City of Naperville

Meeting Minutes

Riverwalk Planning, Design and Construction Committee

Tuesday, June 3, 2025

**Riverwalk East Extension
Hillside Road to Martin Avenue
Considerations - page 1 of 2**

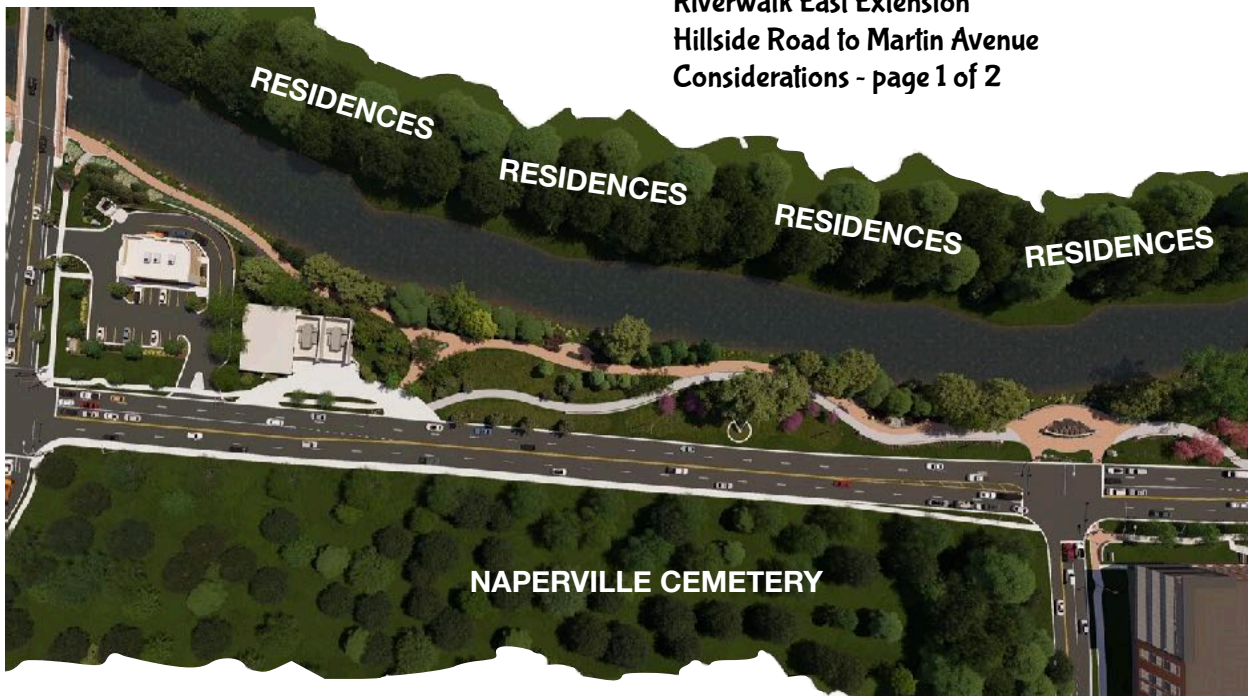
Putting the cart before the horse does throw the baby out. Drawings should reflect vision anchored in reality, to scale, inclusive of context, and consistent with brand. Absent that approach these drawings are spreading misinformation. Nine benches gazing into private backyards?! There are no benches gazing into backyards at north end RW. The electric poles are staying. Pedestrian crosswalks will be marked. Appropriate signage placed.

The Riverwalk is important to the whole community. A \$4M budget is HUGE. Please consider presenting an honest scaled drawing in context that people can believe in.

NOT TO SCALE ~ one example

**NOT ENOUGH
SPACE**
